Work Order ID 148634

Item Name: Quick Release Heli-Utility-Basket™ Long, HD Lid, Spacepod™/Squirrel Cheek Comp.

DART SERVICE INSTRUCTION

TO AMEND INSTALLATION INSTRUCTIONS D350-607-3 Rev.D,
INSTALLATION INSTRUCTIONS D350-607-4 Rev. C AND
INSTRUCTIONS FOR CONTINUED AIRWORTHINESS ICA-D350-607 REV. 6
REF TCCA STC: SH94-14
REF FAA STC: SR00213NY
REF EASA STC: EASA.10016996
REF BRAZILIAN STC: 2007S03-03/-04/-05/-06

FIGURE 1: INSTALLATION OF D4775-041 FWD STRUT

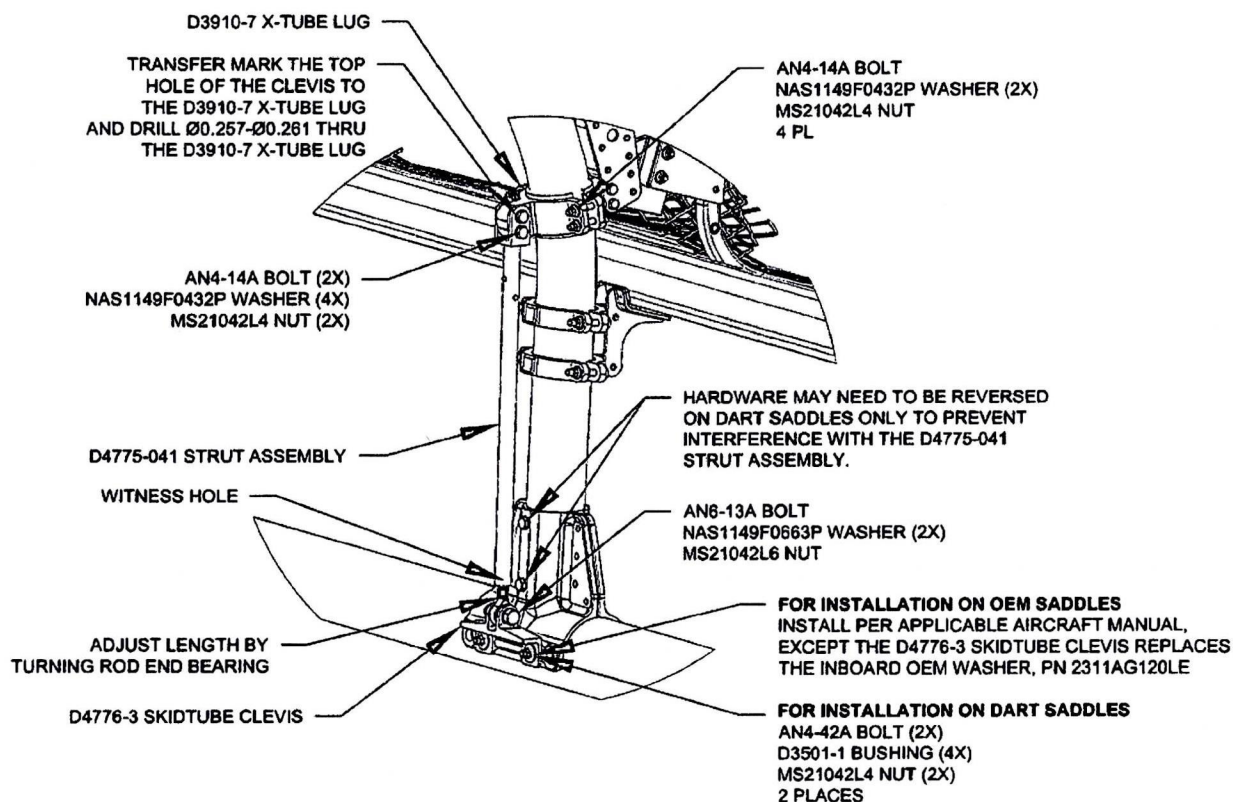
- 3.1 Substitute the Forward Lower D3910-5 X-Tube Lug with the D3910-7 X-Tube Lug as shown in Figure 1.
- 3.2 Install the forward D4775-041 Strut Assembly. Transfer mark from the upper hole on the clevis of the D4775-041 Strut Assembly to the D3910-7 X-tube Lug and drill thru the lug $\varnothing 0.257\text{-}\varnothing 0.261$ as shown in Figure 1. Touch up chemical conversion coating per MIL-DTL-5541. Check the witness holes located at the bottom end of the D4775-041 Strut Assemblies to ensure that the thread from the rod end extends past the witness hole.
Torque MS21042L4/-4 nuts to 50-70 in-lbs (5.7-7.9 N-m). Torque MS21042L6/-6 nuts to 160-190 in-lbs (18.1-21.5 N-m).
- 3.3 Complete the installation in accordance with Installation Instructions D350-607-3 Rev. D or D350-607-4 Rev. C.
